FORT WAYNE COMMUNITY SCHOOLS 2025 GENERAL BUILDING SYSTEMS 2 (GBS2) – FOREST PARK, FRANKE PARK,

Addendum No. 01

February 10, 2025

Project No. 24047

FO-E2.0

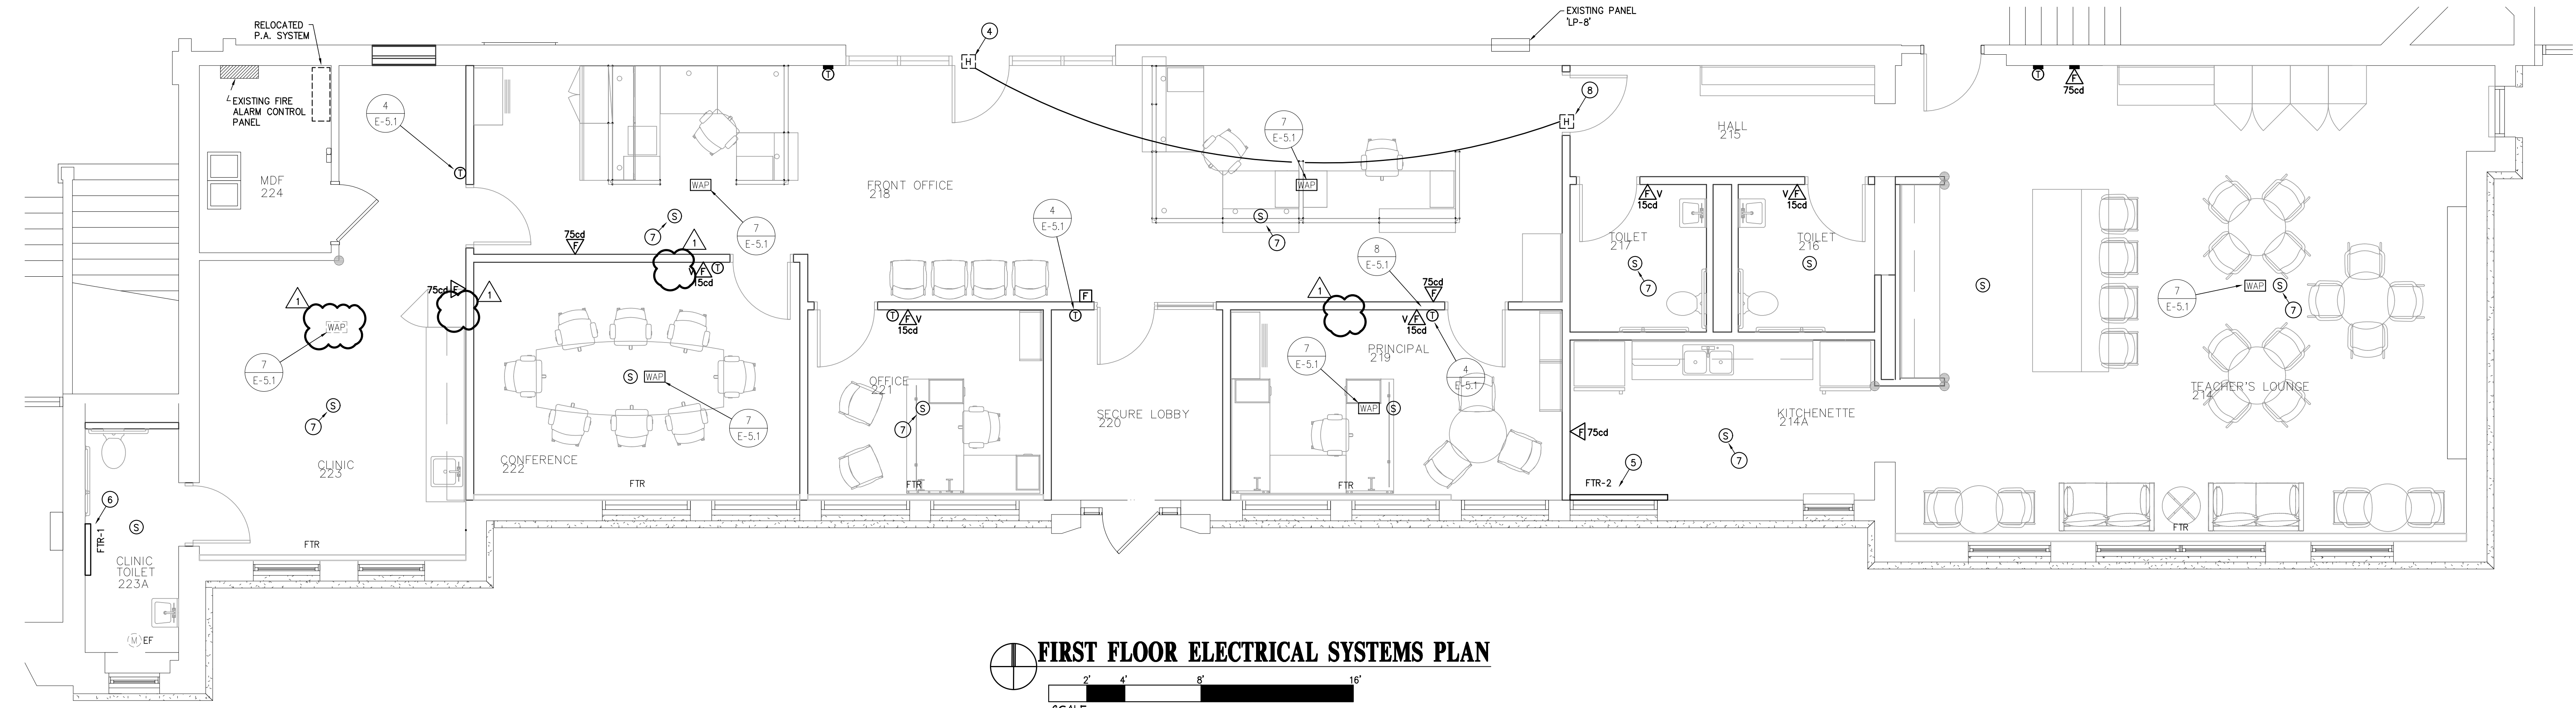
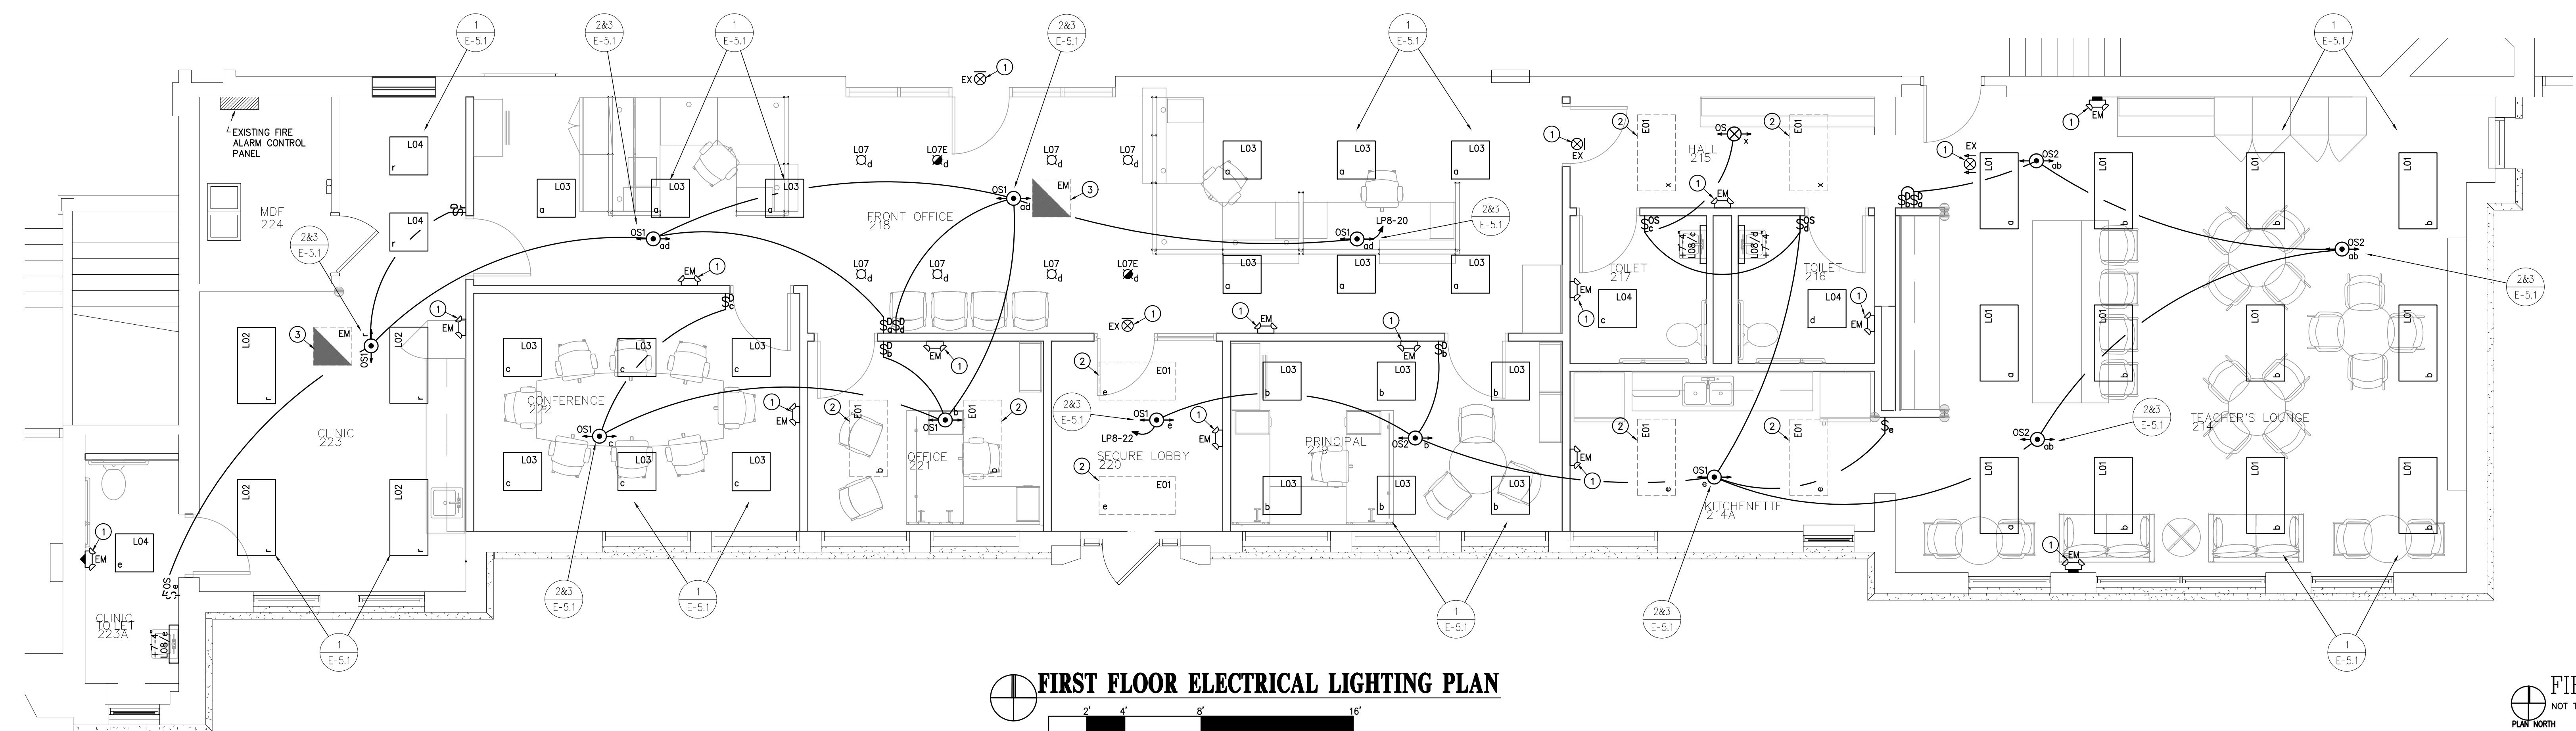
1. Contractor shall refer to revisions on this sheet reflecting owner review comments.
